DESIGN EXCEPTION #DE16-03

RE: Request to Reduce Access Spacing at St. Mary's Hospital East Campus

RE: St. Mary's Hospital East campus Employee Parking Expansion Project
TEDS Design Exception – Access spacing

EXHIBIT

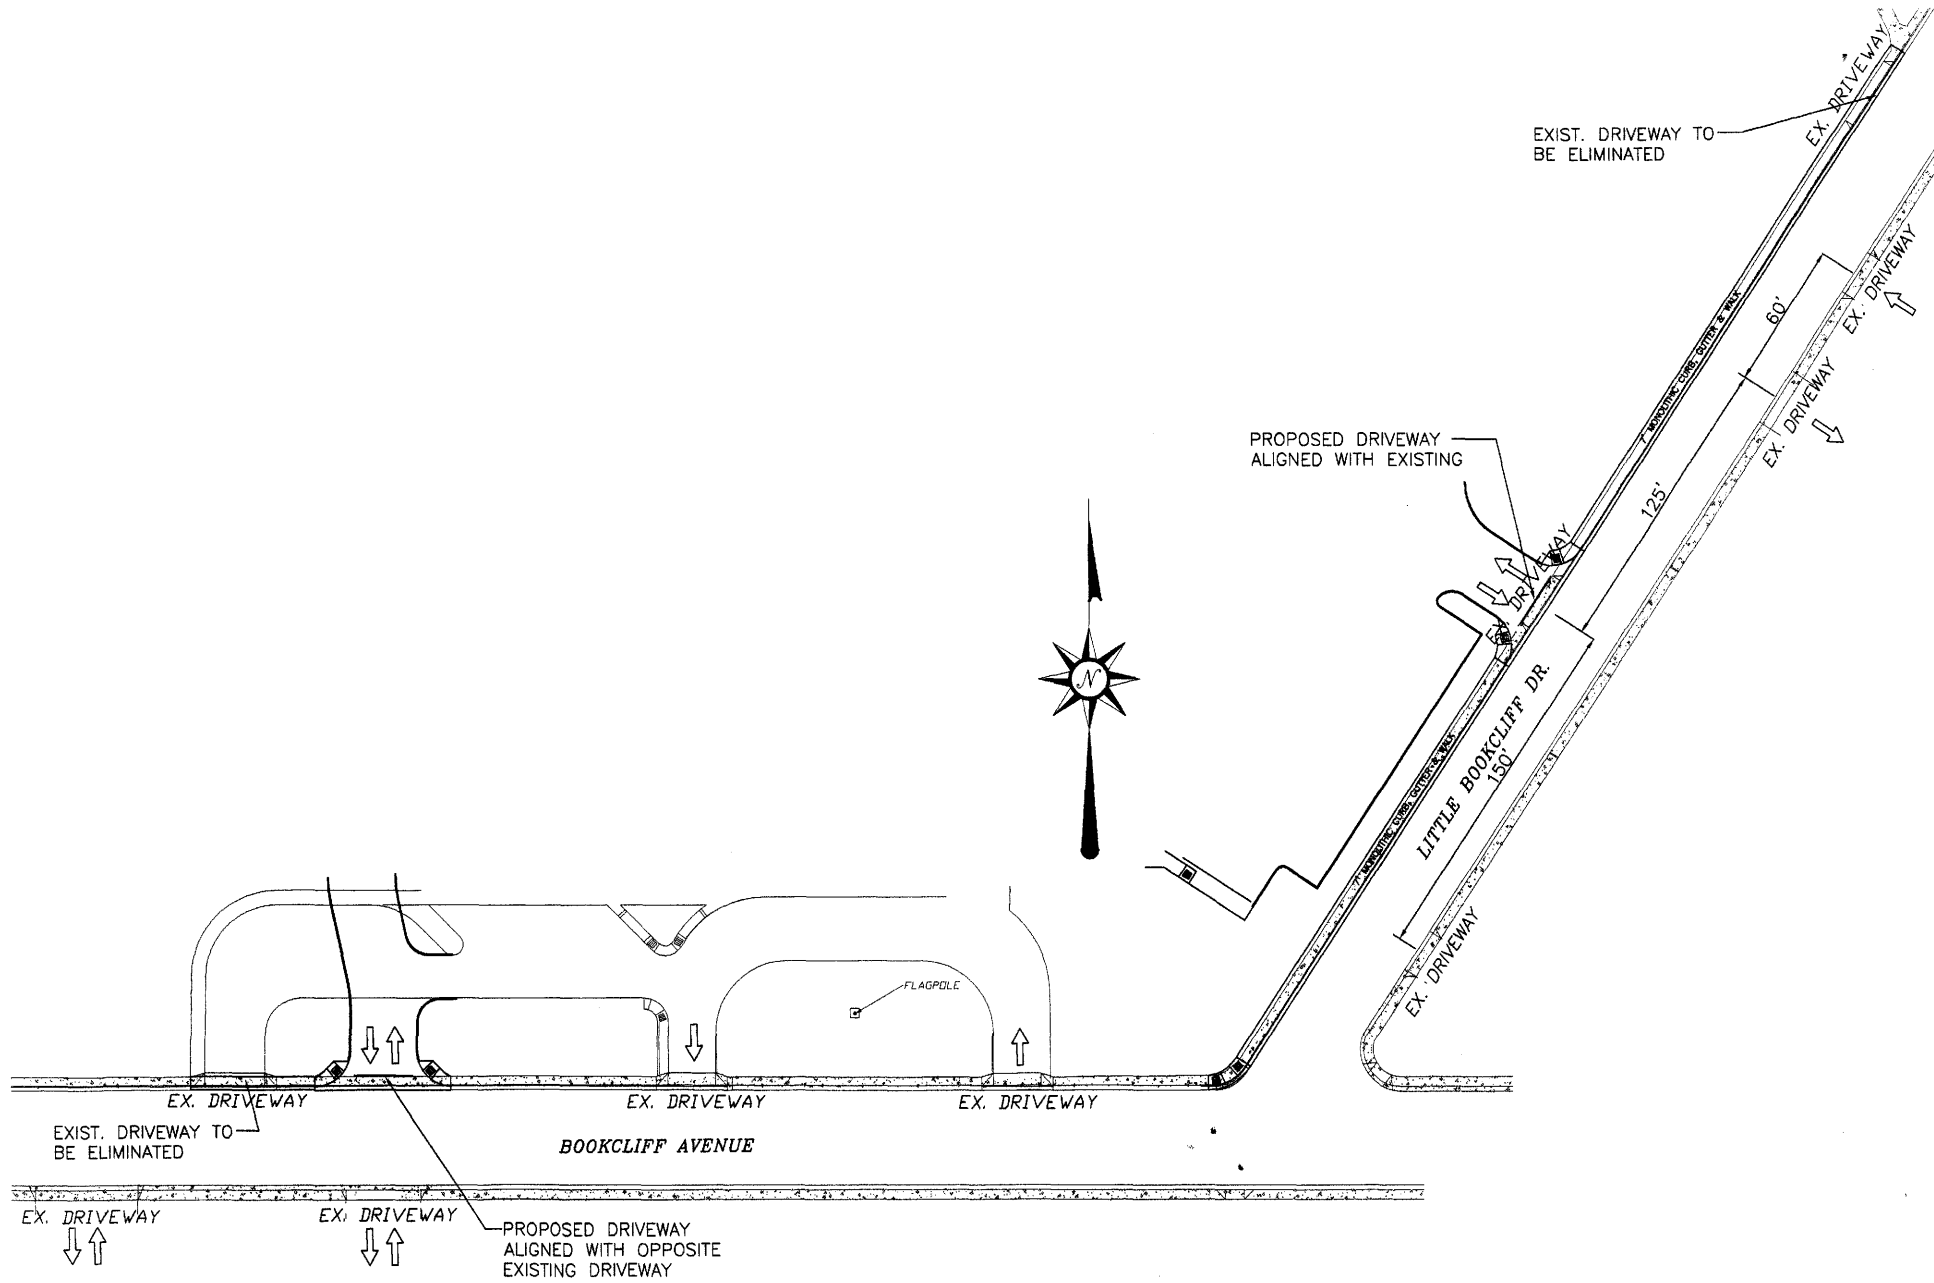
On the Little Bookcliff proposed access, a field investigation revealed that the conflicting access that is 125 feet to the north functions as an entrance only driveway to a row of 8 diagonal parking spaces with a separate exit only driveway 60 feet north of the entrance driveway (see exhibit page 3). Based on this historical use, there should be no exiting turning movements to be in conflict with. The distance to the next closest access to the south is more than the required 150 feet.

I recommend approval of the requested Design Exceptions to Section 4.1.1 to allow proposed location of the new access along the west side of Little Bookcliff Drive.
